amcor

October 11, 2022

Dear Valued Parafilm Customer,

Tail Wipe Mechanism

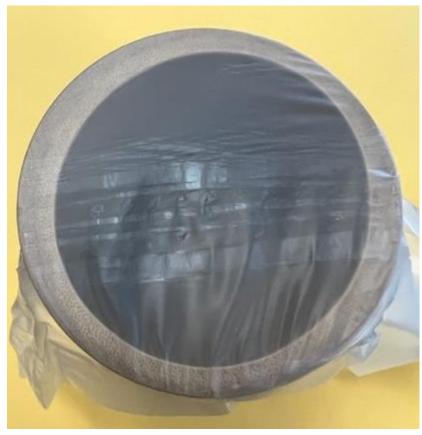
Recently our Parafilm operation has been upgraded from a manual process to an automated solution. The noticeable change in appearance, largely at the top of each roll, is due to our tail wipe system. As the rolls are taken off the line the unsecured end, or tail, must be secured for it to feed down our packaging line. To secure the tails, the finished rolls are spun against a stationary piece with free spinning indentation wheels while light pressure is applied. While this secures the tails, it also causes a visual marking on the material.

Past potentially the first wrap, this marking will be purely a visual defect and will not affect the functionality of the film. The pressure applied is not great enough to puncture the Parafilm to the point where functionality is affected past the first wrap.

Below are pictures of the tail wipe as well as the visual defects you might be seeing on some of the rolls you receive. We understand that the visual appearance is not ideal; however, it will not affect the functionality of the film itself past the first few wraps as you will see below. Please reach out if you are having additional questions on this.
